MR #2023016 – BOWIE MILL ROAD BIKEWAY

NO. MR2023016

Completed: 1/10/2024

- Montgomery County Department of Transportation to construct a sidepath along Bowie Mill Road between Olney-Laytonsville Road and Muncaster Mill Road and along the Muncaster Mill Road between Bowie Mill Road and Needwood Road.

Figure 8: Proposed Guardrail along Muncaster Mill Road

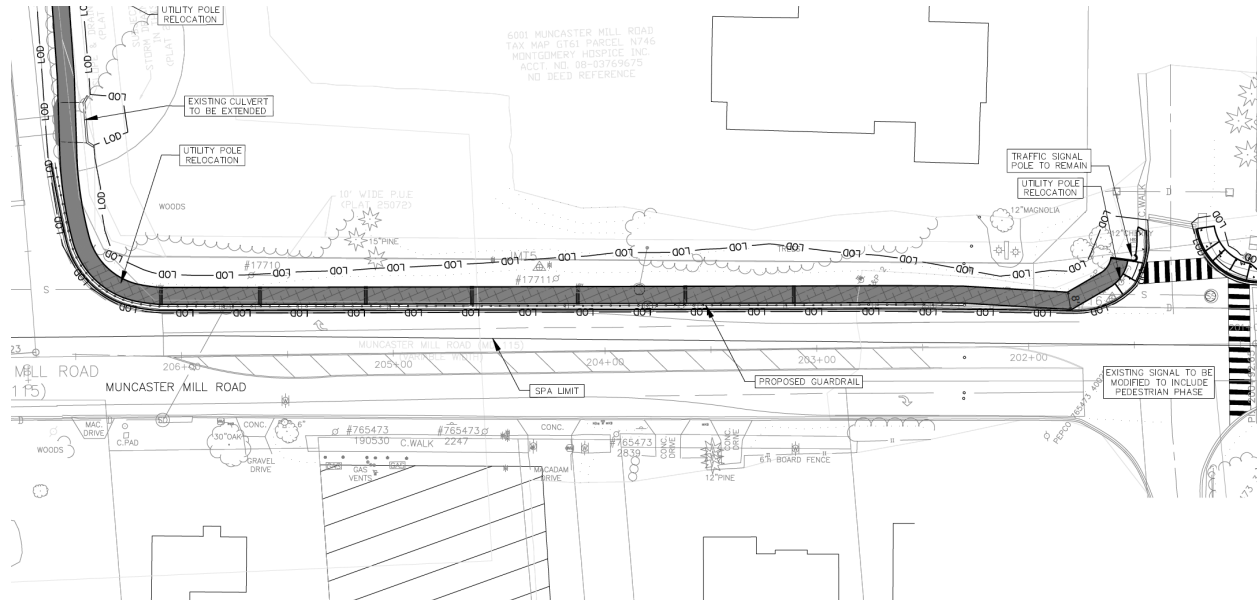
Recommendation: Ensure vertical obstructions, including utility poles, fences and guardrails, are at least two feet from the edge of the sidepath.

Between Stations 202+00 on Muncaster Mill Road and 1+00 on Bowie Mill Road, there is a proposed guardrail immediately adjacent to the eight-foot sidepath (Figure 8). This vertical element narrows the effective width of the sidepath to six feet, which is too narrow for bicyclists to safely pass each other or to pass pedestrians. A two-foot buffer should be provided between this guardrail and the sidepath.

Figure 9: Example Utility Pole Locations Next to Proposed Sidepath

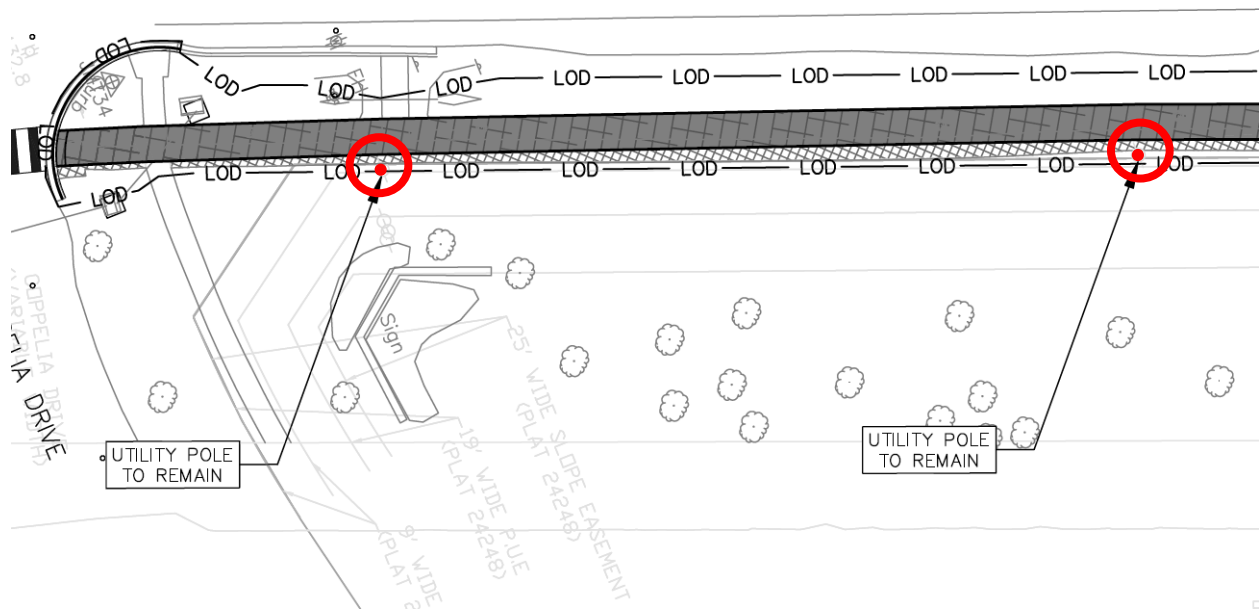
At the following Stations within the project limits, existing utility poles appear to be close to the sidepath (Figure 9):

1. 8+00
2. 10+00
3. 12+00
4. 13+50

- 5. 15+00
- 6. 17+00
- 7. 18+50
- 8. 128+00

Ensure that these utility poles are at least two feet from the sidepath. If not, consider shifting the sidepath or relocating the utility poles as appropriate to maintain the two-foot separation.

Figure 10: Sidepath with Curb Ramp Concern

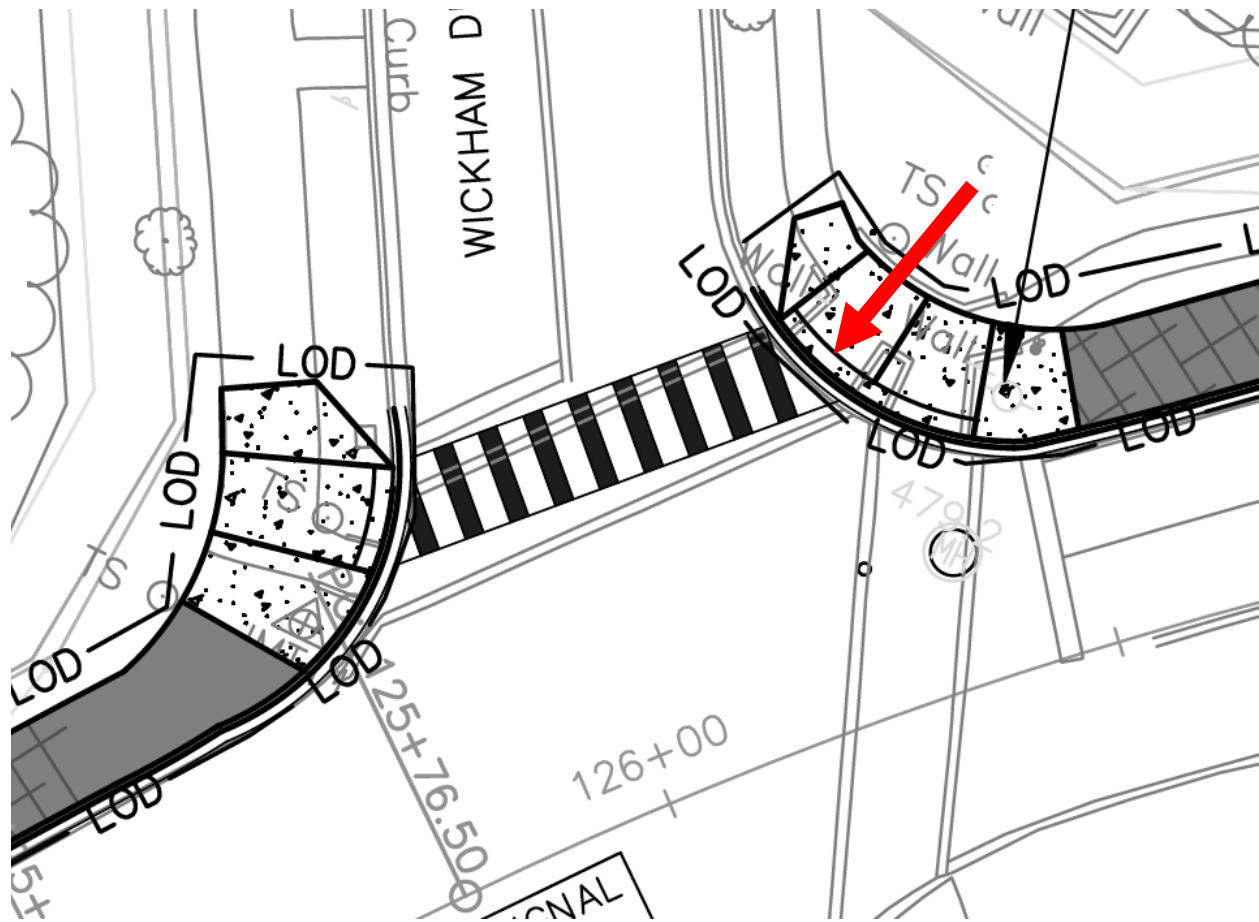
Recommendation: Provide directional curb ramps that are aligned with high-visibility marked crosswalks at all street crossings, including at Stations:

Directional curb ramps aligned with marked crosswalks are a best practice because they guide pedestrians along the shortest path across the street or driveway, reducing pedestrian exposure to traffic. When curb ramps are oriented toward the middle of an intersection (Figure 10), people with low or no vision and those using wheelchairs or other mobility devices can be directed to cross the street outside of the intended path of travel.

Figure 11: Thornhurst Drive Intersection without Connection to Neighborhood to the South

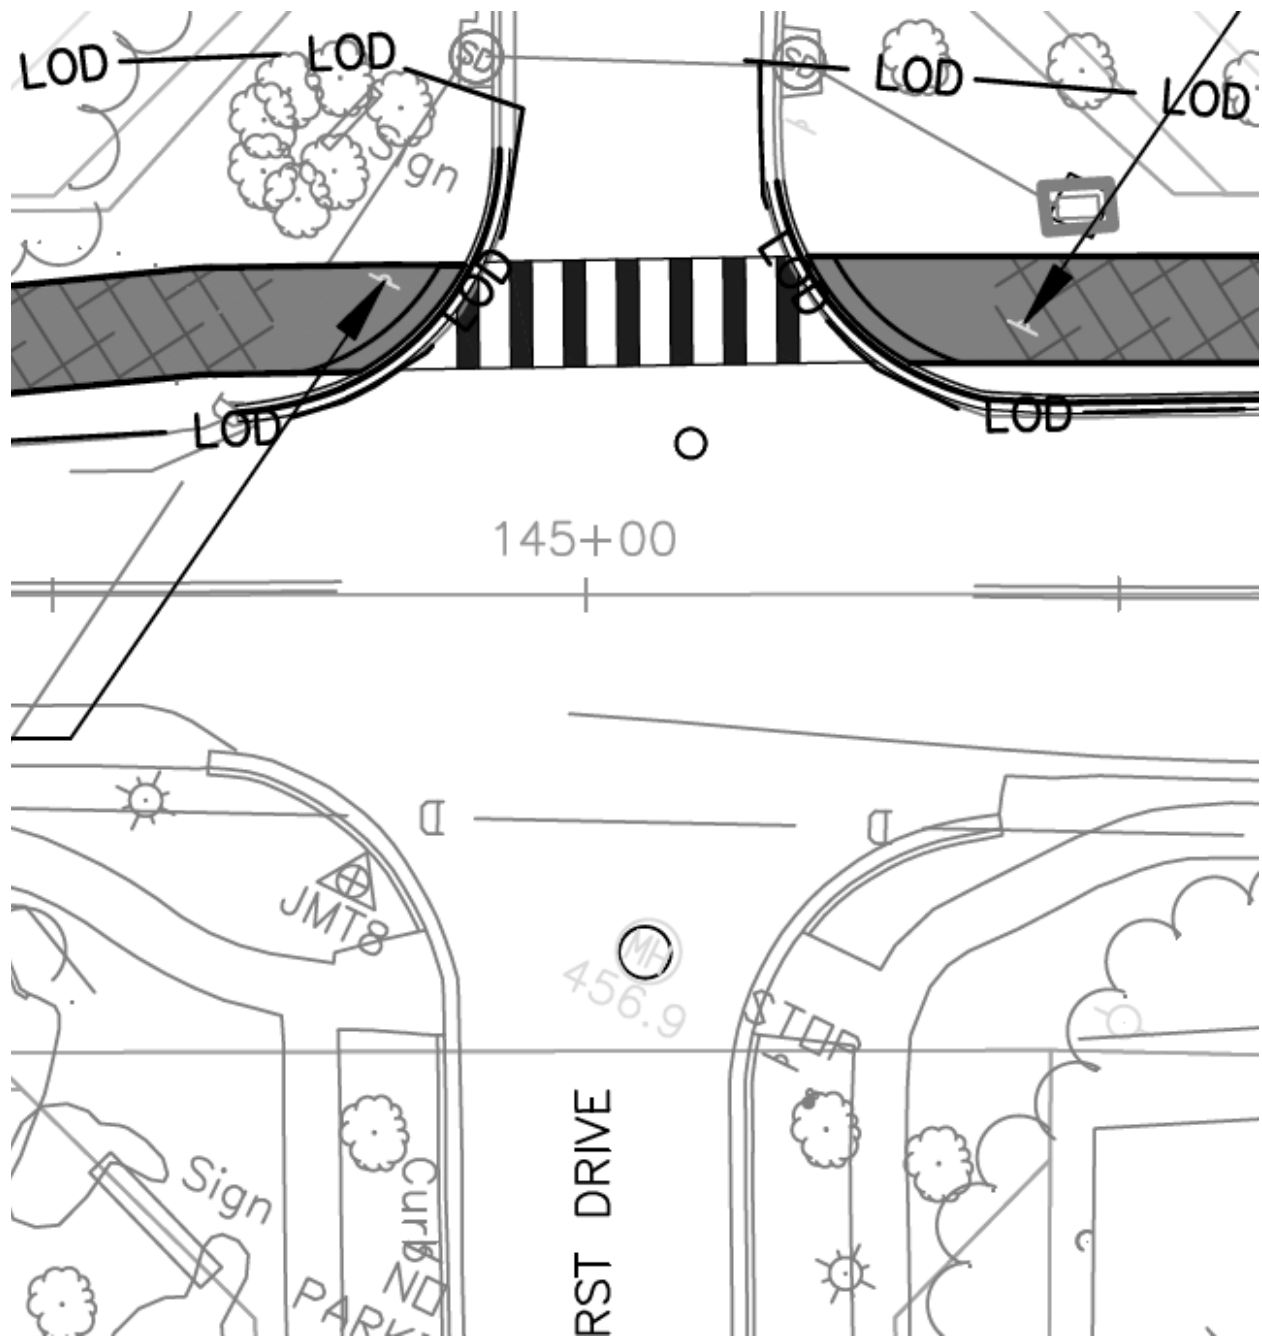
Recommendation: Explore additional protected crossing locations throughout the project area where applicable, specifically at Stations:

There are three intersections within the project extent that connect to residential subdivisions on the opposite side of Bowie Mill Road from the proposed sidepath without either a connecting marked crosswalk or a protected crossing.² An example of this issue is at Thornhurst Drive (Figure 11), which lacks a protected crossing across Bowie Mill Road.

At this location and others, the project team should explore providing protected crossing features to ensure residents can safely access the sidepath and sidepath users can safely access adjacent communities.

Figure 12: Missing Bus Stop at Sequoyah Elementary School

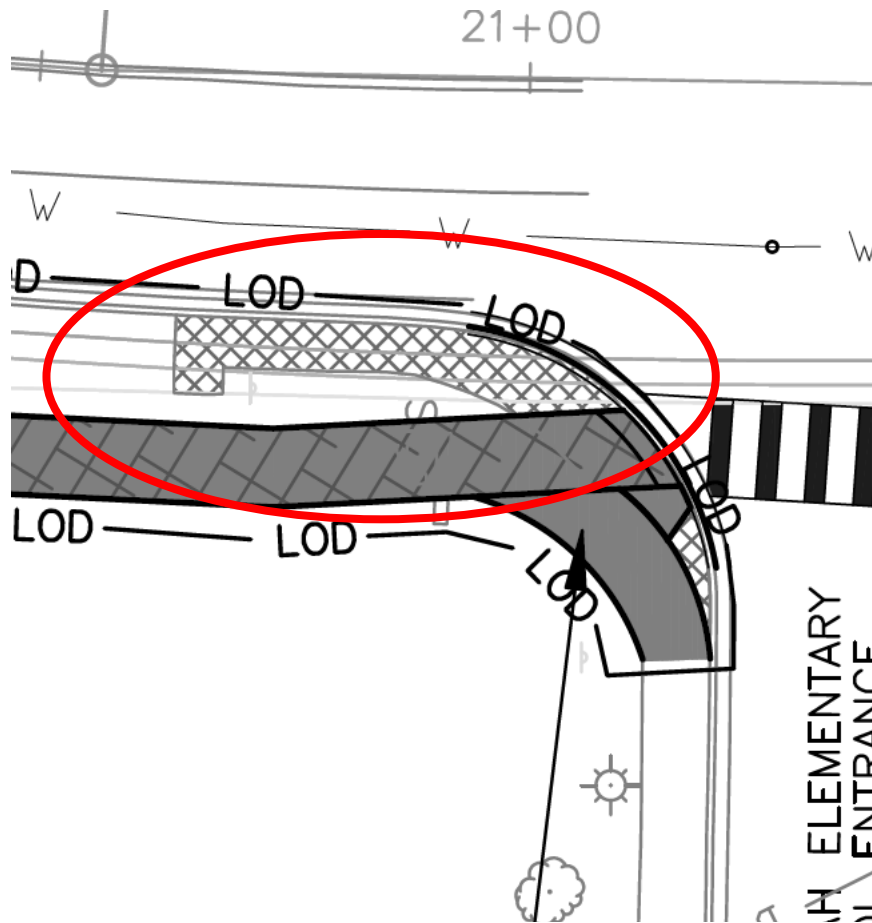
Recommendation: Replace missing bus pad at Sequoyah Elementary School.

At the Sequoyah Elementary School bus stop (21+00), the paved pad where transit riders board and alight from buses appears to be missing. It appears in Google Streetview imagery but is shown as removed without replacement in Figure 12.

Figure 14: Bowie Mill Road at Foggy Lane

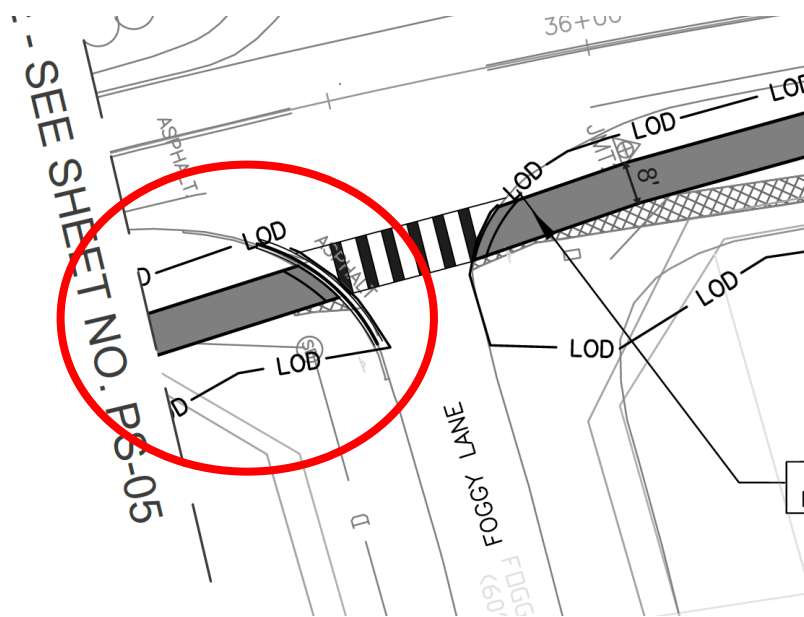
Recommendation: Tighten curb radii at all intersections and driveways in line with the Complete Streets Design Guide (CSDG) default radii (15 feet). Where wider turning radii may be helpful for larger vehicles or emergency operations, consider the use of mountable curbs or relocating the receiving leg stop bar to allow for encroachment.

Additionally, the smaller the curb radius, the less roadway pedestrians have to cross, reducing their exposure to conflict. Figure 15 illustrates the turning radius issue at the circled corner of the intersection with Foggy Lane, but radii across the corridor should be tightened to the extent possible.

Figure 18: Abrupt Sidepath Shift East of Sequoyah Elementary School

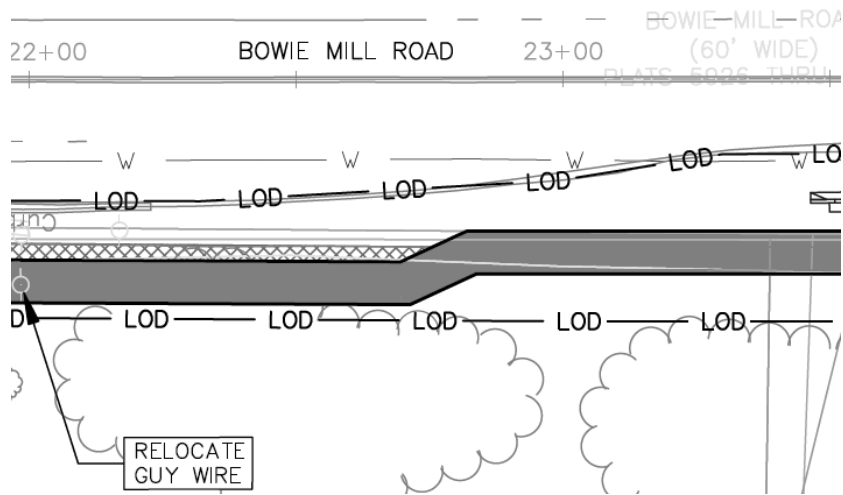
Recommendation: Smooth abrupt shifts in the sidepath alignment at Stations:

There are several locations where the sidepath shifts horizontally in a manner that may be unsafe for users, particularly bicyclists. Figure 19 identifies one such location. The *Bicycle Master Plan* Bicycle Facility Design Toolkit indicates that the maximum “lateral taper” or horizontal shift should be at a 3:1 ratio or one foot horizontal for every three feet along the sidepath. The project team should ensure that all changes in horizontal sidepath alignment are not more aggressive than 3:1.

Figure 19: Northern Sidepath Terminus

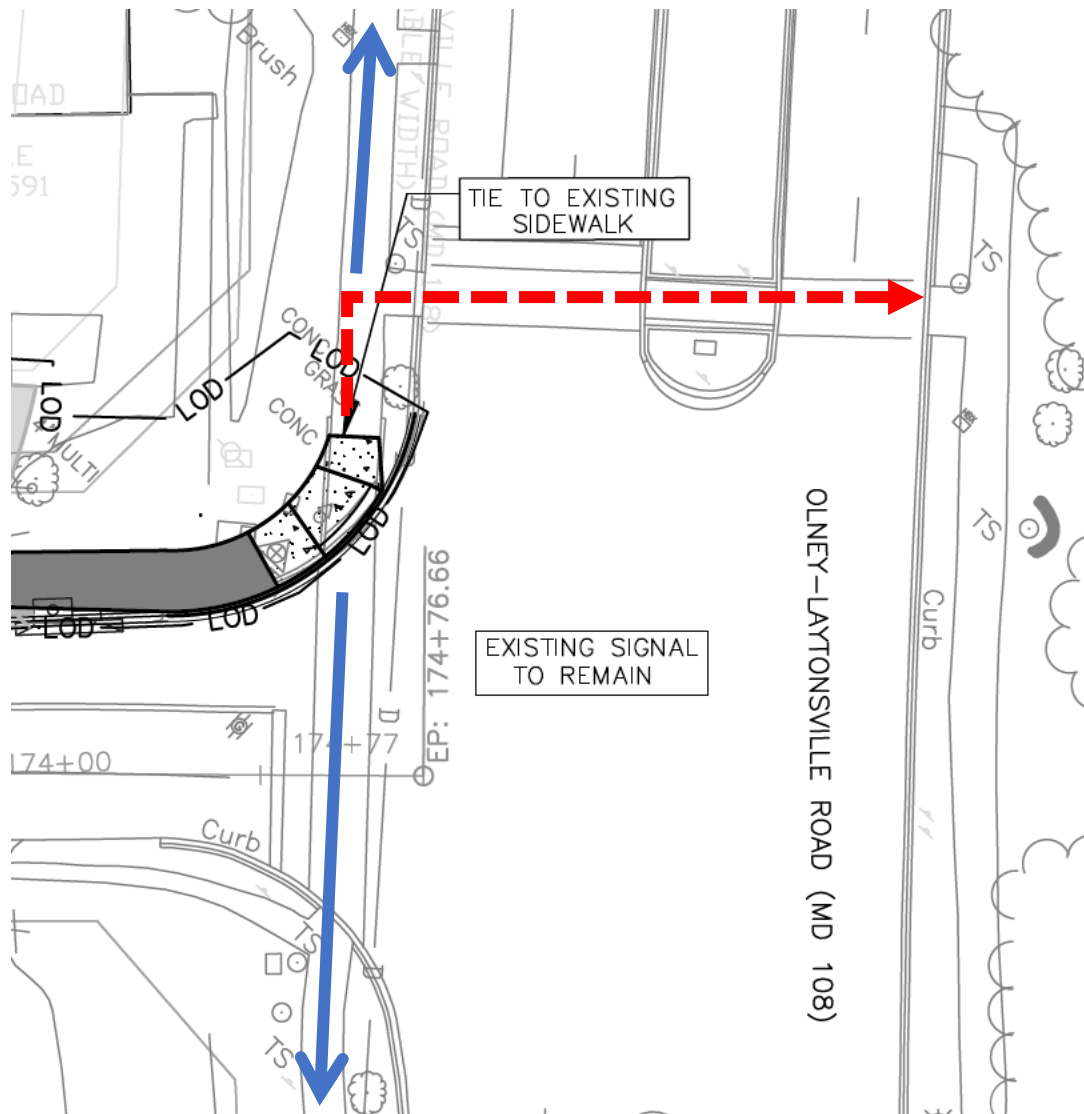
Recommendation: Extend the Bowie Mill Road sidepath to the pedestrian crossing at Olney-Laytonsville Road so that it connects with the existing sidepath along the north side of Olney-Laytonsville Road.

As currently designed, the proposed sidepath ends at the corner of Bowie Mill Road and Olney-Laytonsville Road as shown in Figure 20. Bicyclists would want to cross Olney-Laytonsville Road to use the sidepath along its north side (the dashed red path in the figure below) will have to use a 25-foot-long section of sidewalk to access the crossing, creating a potential pinch point for users. To mitigate this conflict, the proposed project should be extended to this protected crossing location at sidepath width.

Figure 20: Narrow Sidepath with Minimal Buffer

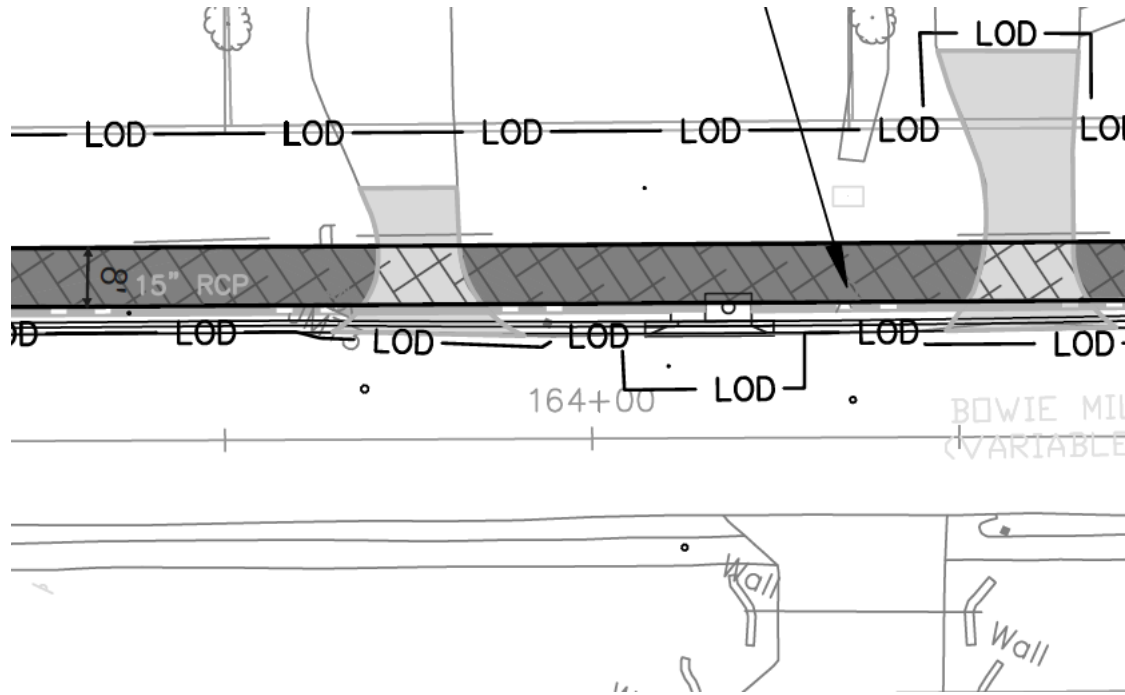
Recommendation: Explore opportunities to provide a wider sidepath and street buffer between the sidepath and Bowie Mill Road between Briars Road and Olney-Laytonsville Road.

Between Briars Road and Olney-Laytonsville Road, the sidepath narrows from the standard ten feet for areas outside of Special Protection Areas to eight feet, and has a one to two-foot-wide street buffer, as shown in Figure 20. Reducing the width of the sidepath and the street buffer as it nears Olney-Laytonsville Road Center is problematic, as Planning staff would expect more walking and bicycling at this end of the sidepath given the proximity to Olney Town Center. At the same time, a wider street buffer is preferred to minimize the likelihood of bicyclists or pedestrians unintentionally entering the roadway. The default street buffer width for this street type (Area Connector) will be six

feet in the coming update to the CSDG. Further project design should investigate widening the sidepath and street buffer, with a preference for a wider street buffer if both are not possible.

Figure 26: Area of Perpetual Easement for MCDOT Right-of-Way at North Branch SVP 3

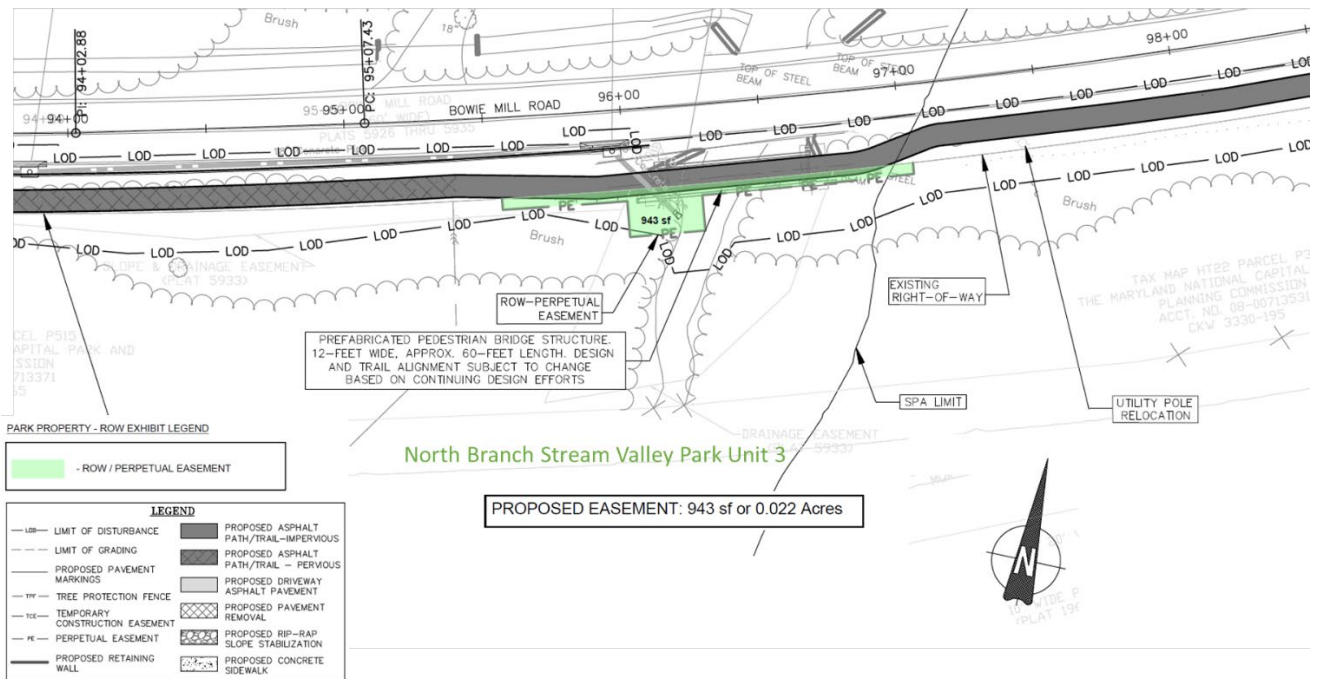
Recommendation: Any approved Commission parkland such as North Creek Stream Valley Unit 3 to be added to the Montgomery County Department of Transportation Road right-of-way (ROW) will be transferred to the County, as appropriate, via perpetual easement. The Commission must be paid the fair market value of the perpetual easement prior to the issuance of a Park Construction Permit.

The permanent impact will result in the creation of additional MCDOT right-of-way totaling 943 square feet (through the granting at fair market value of a perpetual easement) from North Branch Stream Valley Park Unit 3 (Figure 27).
